MMO Reference: DCO/2021/00002
Planning Inspectorate Reference: EN010119
Identification Number: 20051047

Planning Act 2008, Proposed North Falls Offshore Wind Farm Project Order Deadline 4 Submission

This document comprises the MMO's submission for Deadline 4.

Figure 1: Screenshot of the sediment sample locations (obtained from NF-M-DES-0033-0002-GrabSampleLocations-R00.pdf) **Key:** | = Current array area and Export Cable Corridor (ECC). Hatched = Original array area and ECC. Points = Sediment sample sites.

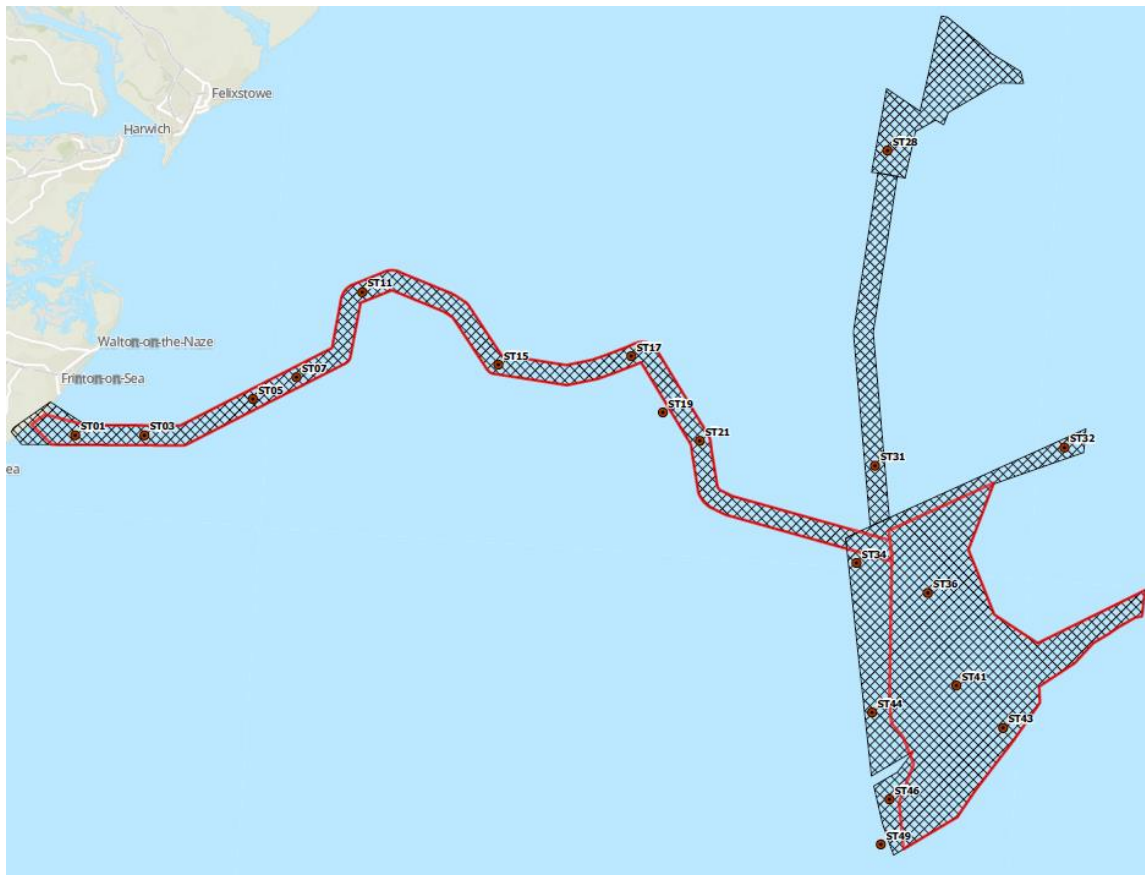
- 5.2.1 The MMO notes that in total 39 surface samples were taken from across the Projects Array and Export Cable Corridor (ECC) areas; 19 samples (those visualised in Figure 1) were taken for particle size analysis (PSA), trace metals (including arsenic), Polycyclic aromatic hydrocarbons (PAHs) and Polychlorinated biphenyls (PCBs) whilst the remaining 20 samples (not visualised in Figure 1) were only analysed for PSA, with the Applicant stating that these are exempt from chemical analysis. The sediment coordinates supplied in the shape file for the 19 samples analysed for contaminants are in-line with those pictured in Figure 1. The MMO is content that the 19 samples analysed for contaminants provide adequate spatial coverage across the dredge area.

- 5.2.2 The MMO has not been able to locate a sample plan for this sediment sampling and therefore cannot determine if this is in-line with the sample plan requested, if one exists, and if the 20 samples exempt from chemical analysis had been agreed prior to this advice. No justification has been provided for the exempted samples and the Applicant should clarify their reasonings for this and should also note that these should be provided in the future alongside sediment samples.

- 5.2.4 The PSA indicates that the sediment composition for the majority of samples in Figure 1 (those analysed for contaminants) are predominantly composed of sand (39% - 99%) followed by gravel (0.1% - 31%) and silt / clay (0% - 41%). Five samples (ST01, ST07, ST17, ST28 and ST36) are predominantly composed of gravel (48% - 64%) followed by sand (29% - 42%) and then silt / clay (5% - 19%). One sample (ST03) is predominantly composed of silt / clay (55%) followed by sand (30%) and then gravel (13%). The average sediment composition for the 20 samples not analysed for contaminants indicates they are predominantly composed of sand (64%) followed by gravel (22%) and then silt / clay (13%). The average grain size of the sand in these samples indicates that the majority of samples are 'very coarse' sand (40%) followed by 'medium' sand (15%) and then 'fine' sand (8%). Out of these 20 samples only one (ST02) has a majority silt / clay composition (74%); if the numbering of samples are in order and away from shore, this would indicate that the two samples with majority silt / clay composition (ST02 and ST03) are closer inshore.

5.2.8 In summary, the 19 sediment samples in Figure 1 are considered acceptable for disposal at sea given the low levels of trace metals, PAHs and PCBs within the material.

5.3.1 The MMO notes that six of the 19 sample locations in Figure 1 are within the Five Estuaries ECC (TH019) disposal site which is currently open. As such, the ECC and Array area for NFOWF and their respective disposal sites will overlap with Five Estuaries ECC (TH019) disposal site. Two disposal sites cannot overlap and due to the stage of Five Estuaries we cannot close the disposal site. Therefore, we require the following to ensure the disposal site can be designated:

- 1) A new shapefile for the cable corridor of Five Estuaries and North Falls together to allow us to update TH019 to be the whole area – noting the DCO only allows deposits within the order limits for both projects. This will mean no changes are required to the Five Estuaries DML and although the name will still remain as Five Estuaries, North Falls can utilise the site.
- 2) The Map in Figure 3 below is from <https://map.4coffshore.com/offshorewind/> and the MMO note the ECC for Five Estuaries may be different. The gap in the middle between both cables will need to be included in the disposal site as it needs to be one continuous area.
- 3) An updated site characterisation report to explain this and please include a map of the whole site and provide information on the volume to be disposed within this site.

Figure 2: LMW PAH levels in sediment samples from the project (obtained from North Falls Survey Data.xls)

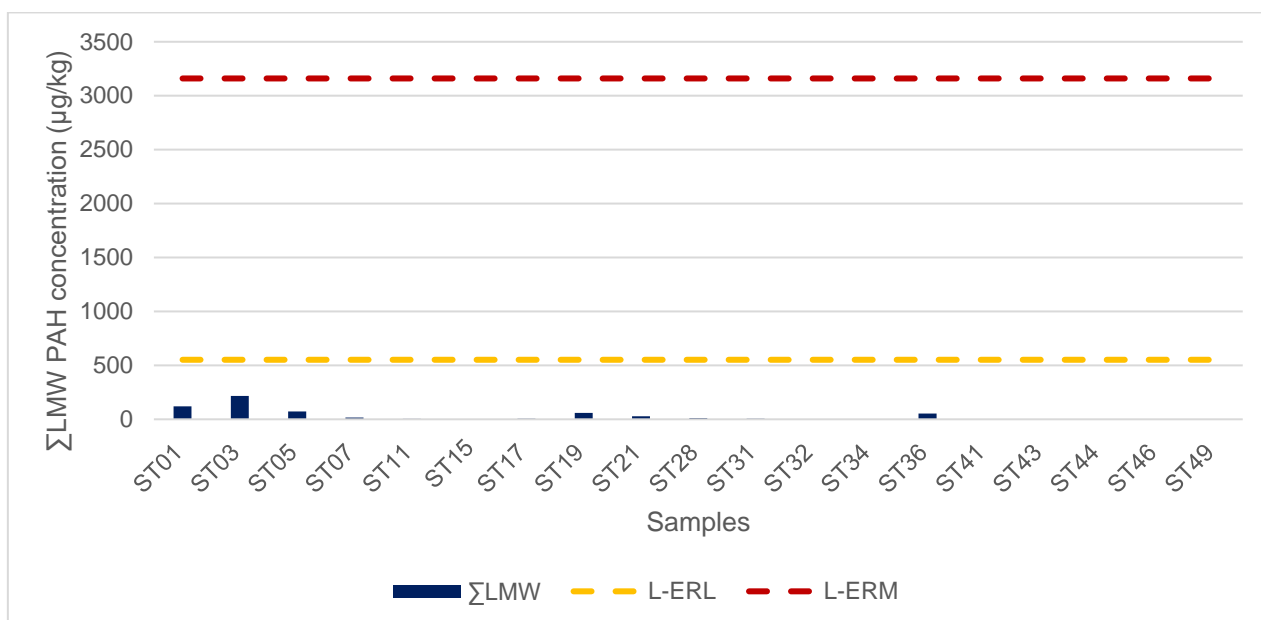
5.2.6 The MMO uses the best available evidence for assessment and therefore refers to the recommendations in Mason et al. (2022), which in this case in the absence of a defined AL2 for PAHs the Gorham-Test approach is utilised (Gorham et al., 1999; Long et Al., 1995; 1998). It should be noted that these recommended guidelines are not formally agreed ALs and their use is advisory. This is an effects-range approach which considers the sum total of a number of the low molecular weight (LMW) PAH analytes which are seen as acutely toxic, and a selection of the high molecular weight (HMW) PAH's that are considered to be more long-term acting (i.e. carcinogenic) which are compared for each sample for two effects ranges. Total values of the LMW PAHs and the total of the HMW PAHs are calculated and then compared to threshold values. If a total value (for either LMW or HMW selection of PAHs) does not exceed the effects-range low (ERL), the indication is that the sediment in the sample can be considered low risk. If a total value exceeds the effects-range median (ERM) for either the LMW or the HMW total values, it can be considered higher risk, with more likelihood of harm occurring. The LMW and HMW levels are displayed in Figures 2 and 3 and indicate that all samples contain levels of both LMW and HMW PAHs below the ERL and in some cases below the LOD. The material in respect to PAHs is considered acceptable for disposal at sea.
